WATERTOWN, SOUTH DAKOTA FLOOD RISK MANAGEMENT GENERAL INVESTIGATIONS STUDY

FINAL INTEGRATED FEASIBILITY REPORT & ENVIRONMENTAL ASSESSMENT

APPENDIX J: PUBLIC INVOLVEMENT

Figure 1. River Weir Wooden Stop Log Plan View [HDR, 2001].

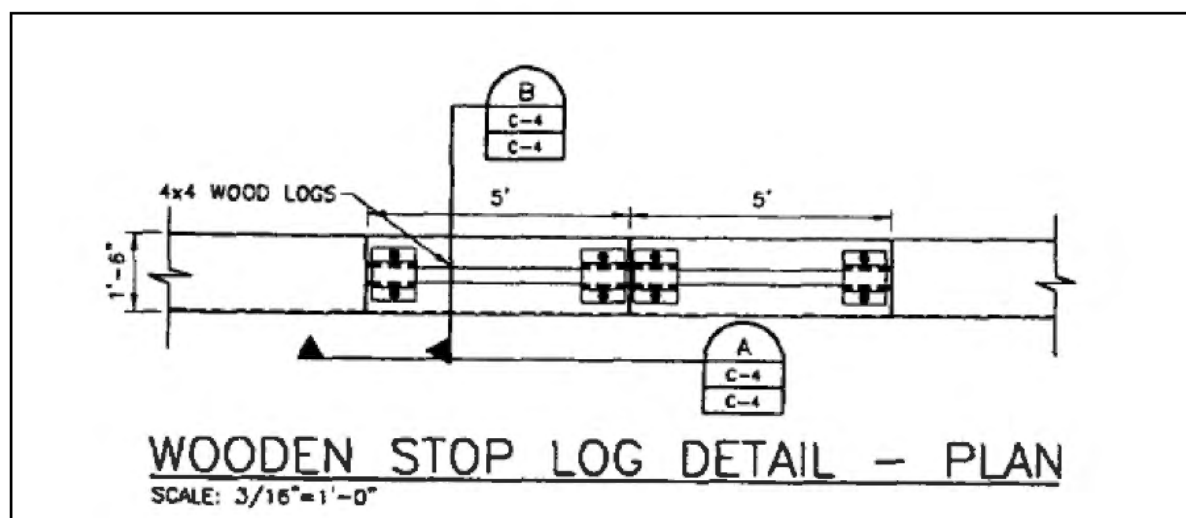
RESPEC assumes that the "low flow gates" are the sluice gates in the sediment diversion structure; however, the changes that are being proposed to the river weir where the flashboards (stop logs) are located are unclear. Furthermore, the Draft FR/EA does not acknowledge that both weir structures and their respective operating criteria are governed by Flood Control Permits FC-3 and FC-29, and does not provide detail regarding required changes in operation for the TSP to function as proposed.

The existing river weir was (re)constructed in 2002 with the purpose of controlling and maintaining the level of Lake Kampeska. Stamped plans for the project are found in the documentation for FC29-3, produced by HDR and dated April 2001. According to the plans, the river weir has a crest elevation of 1,718.8 feet and includes a stop log structure through the weir with a bottom elevation of 1,717.8 feet (the total depth of the stop log structure is 1.0 foot). The stop log structure itself consists of two sets of 5-foot stop logs adjacent to one another, as shown in Figures 1 and 2 (note elevations in Figure 2 are in the National Geodetic Vertical Datum of 1929 [NGVD29] datum). According to District representatives, repairs and improvements have since been made to the river weir to prevent the Big Sioux River from bypassing the structure.

Figure 2. River Weir Wooden Stop Log Section. Elevations in the figure are in the NGVD 29 Datum (add 1.0 foot for NAVD 88 datum).

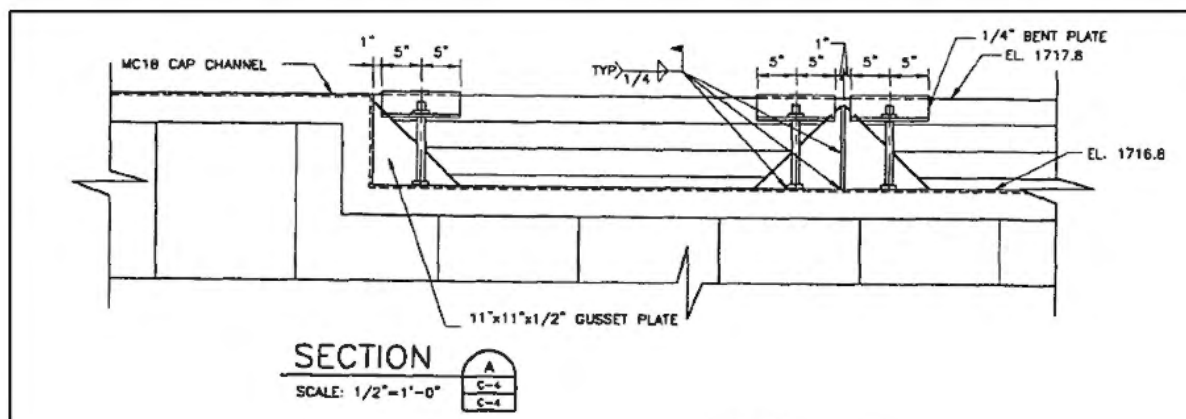
The Draft FR/EA [USACE, 2024] assumes that, under existing conditions, the elevation of Lake Kampeska is typically full prior to spring runoff, at 1,718.8 feet. Analysis of past Lake Kampeska daily elevation data from 2001 to 2024 indicates that median elevation in February and March ranges from 1,718.7 to 1,718.9 feet, and thus an assumed elevation of 1,718.8 feet seems reasonable. The Draft FR/EA states that the TSP will include removing stop logs in the fall to lower the lake elevation through the fall and winter. The assumption is that the lake elevation will reliably drop to elevation 1,718.0 feet before spring runoff and provide an additional 3,300 acre-feet of flood storage in Lake Kampeska compared to existing conditions. The stop logs would then be put back in place after spring runoff to set the lake elevation back to 1,718.8 feet.

RESPEC assumes that flow through the stop log structure will determine lake elevation, based on the structure's elevation-discharge relationship. A basic elevation-discharge rating curve was estimated for the stop log structure, shown in Figure 3, using equations to represent two trapezoidal weirs based on the stop log structure geometry.

Figure 3. Estimated Elevation-Discharge Rating Curve for the Stop Log Structure.

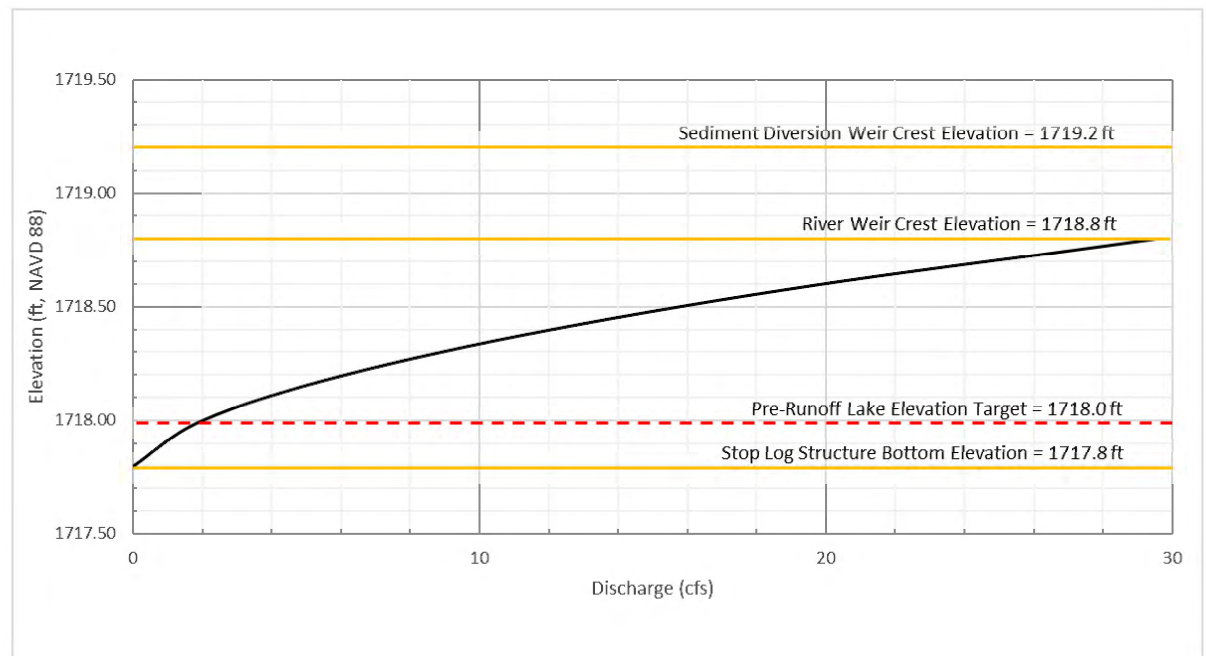
This estimated rating curve for the stop log structure suggests that the desired pre-runoff water surface elevation of 1,718.0 feet corresponds with a flow rate of about 2 cubic feet per second (cfs) on the Big Sioux River at the river weir. This further suggests that flow in excess of 2 cfs during the lowering period from fall until spring runoff could prevent achieving the desired lake elevation of 1,718.0 feet.

The results of this analysis suggest that the seasonal lowering of Lake Kampeska is impracticable as proposed (simply removing stop logs) and unable to reliably provide 3,300 acre-feet of additional flood storage from year to year as compared to existing conditions. Factoring in an initial lake elevation based on this analysis for proposed conditions in the hydraulic model would seem appropriate; in essence, the assumed initial lake elevation should be higher than 1,718.0 feet for this alternative as proposed, which would ultimately reduce the calculated benefit of the alternative, lowering the benefit-cost ratio (BCR). Alternatively, structural modifications to the river weir would be needed to reliably implement seasonal lowering, which would come with significant additional costs and challenges for implementing, also lowering the BCR.
